NEC Code-Making Panel 7 (NEC P07) NFPA 70 Second Draft Meeting (Annual 2025)

October 21 - 23, 2024
8:00 a.m. – 5:00 p.m. (PT)

NFPA NEC Code-Making Panel 7 NFPA 70 First Draft Meeting (Annual 2025)

Figure 550.10(C) 50-Ampere, 125/250-Volt Receptacle and Attachment Plug Cap Configurations, 3-Pole, 4-Wire, Grounding-Types, Used for Mobile Home Supply Cords and Mobile Home Parks.

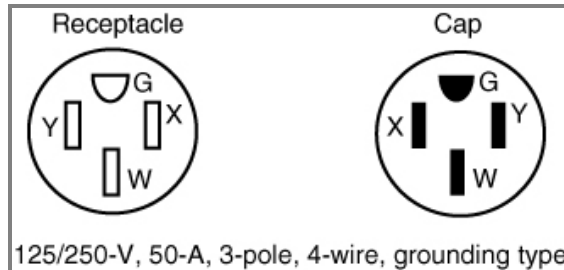
The attachment plug cap shall be a 3-pole, 4-wire, grounding type, rated 50 amperes, 125/250 volts with a configuration as shown in Figure 550.10(C) and intended for use with the 50-ampere, 125/250-volt receptacle configuration shown in Figure 550.10(C). It shall be listed, by itself or as part of a power-supply cord assembly, for the purpose and shall be molded to or installed on the flexible cord so that it is secured tightly to the cord at the point where the cord enters the attachment plug cap. If a right-angle cap is used, the configuration shall be oriented so that the grounding member is farthest from the cord.

Figure 552.44(C)(1) Attachment Cap and Receptacle Configurations.

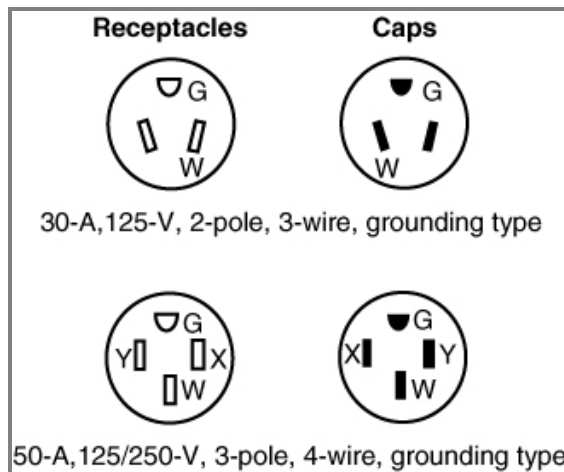
Park trailers having a feeder assembly rated 50 amperes as permitted by 552.43(B) shall have a 3-pole, 4-wire grounding-type attachment plug rated 50 amperes, 125/250 volts, conforming to the configuration shown in Figure 552.44(C)(1).
